SERVICE BULLETIN

Service Bulletin No.: DA20-24-04 Rev 0

Title: Replacement of Battery Relay Contactor

Figure 1: Relay Junction Box – Firewall

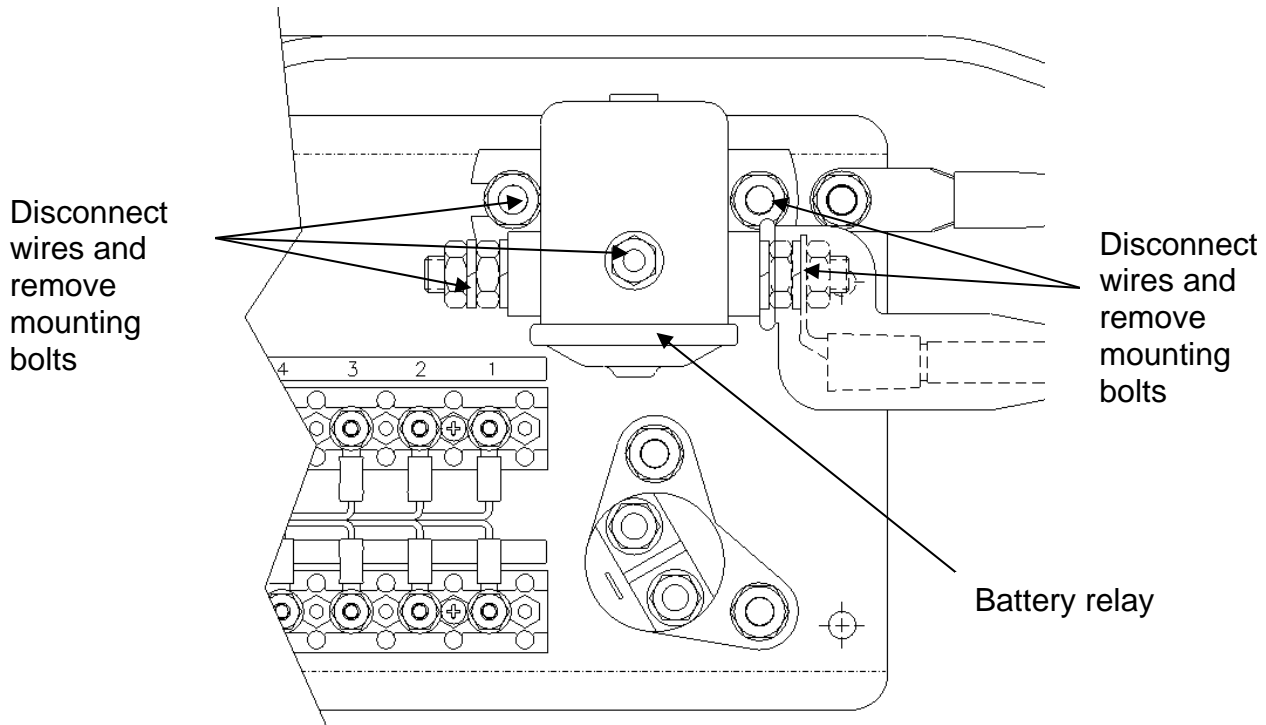
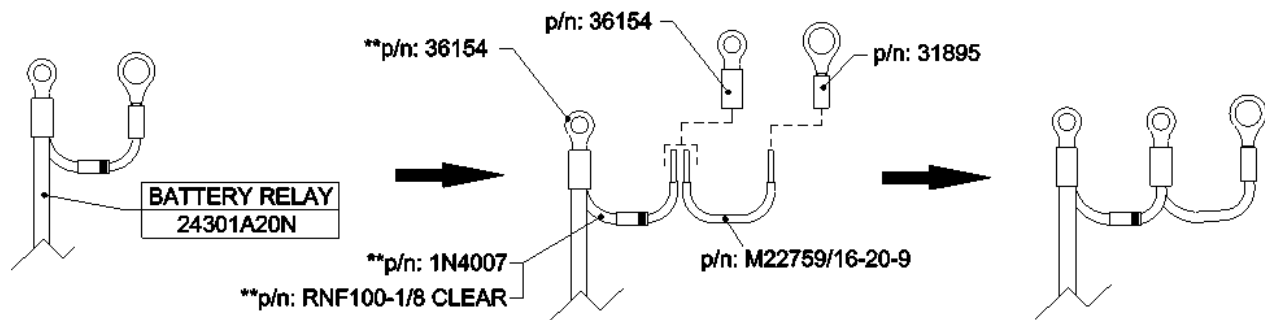
8. **Special Tools:** none
9. **References:** DA20-A1 Aircraft Maintenance Manual (AMM), Document DA201-A1
10. **Accomplishment Instructions:**
 - 10.1 Remove the upper cowl in accordance with AMM DA201-A1, Chapter 71-10-00.
 - 10.2 Disconnect the aircraft battery cables from the battery.
 - 10.3 Remove the battery relay contactor as show in Figure 1.

Figure 3: LAMAR relay installation

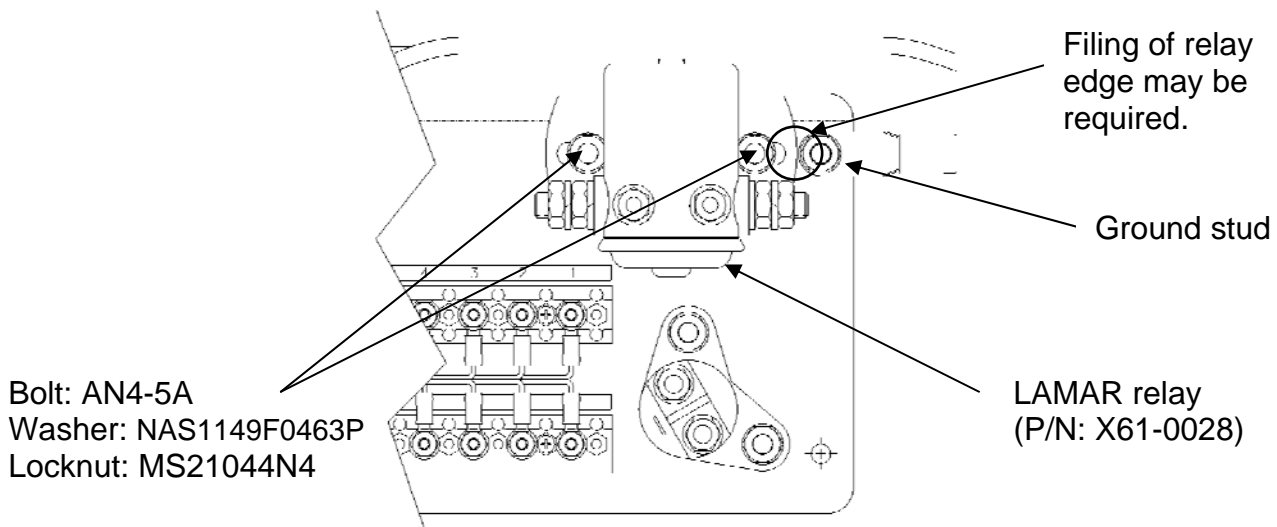
10.3.2 Install the new battery relay (P/N: X61-0028) using the supplied hardware, as shown in Figure 3.

NOTE: Relay mounting edge may need to be filed for clearance with ground stud. If filing is required apply suitable surface protection to all areas where filing occurs (Nycote 7-11 or equivalent).

Figure 4: Relay wire attachments

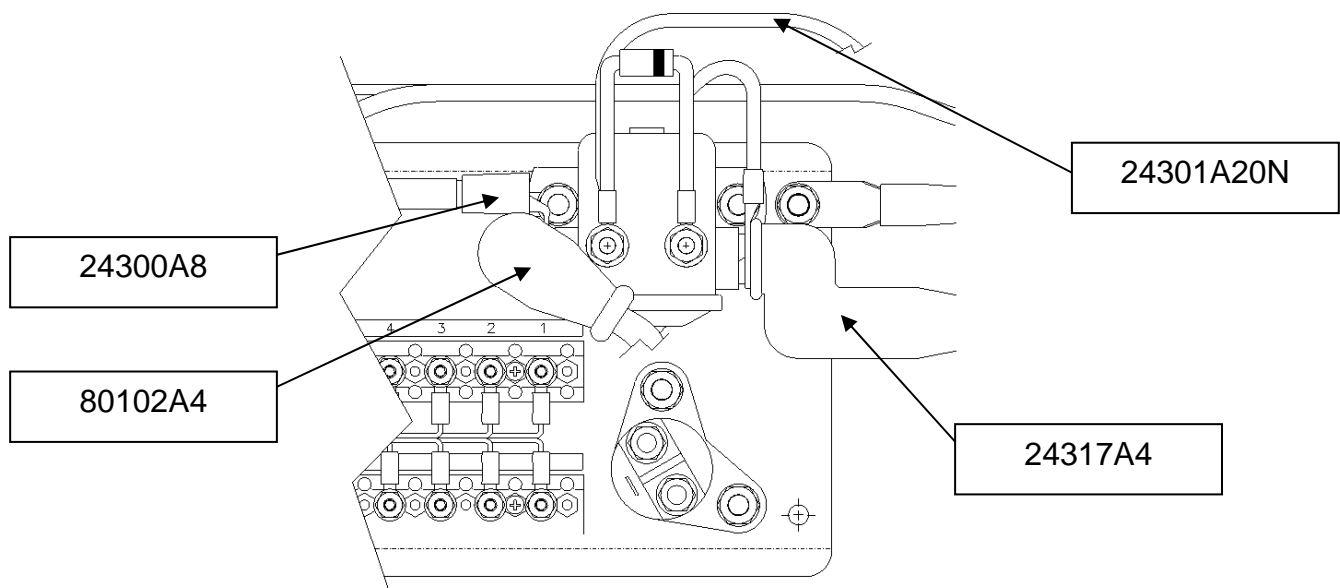
10.3.3 Connect the battery relay cables as shown in Figure 4. Secure with supplied cable ties (P/N: MS3367-5-9) as required.
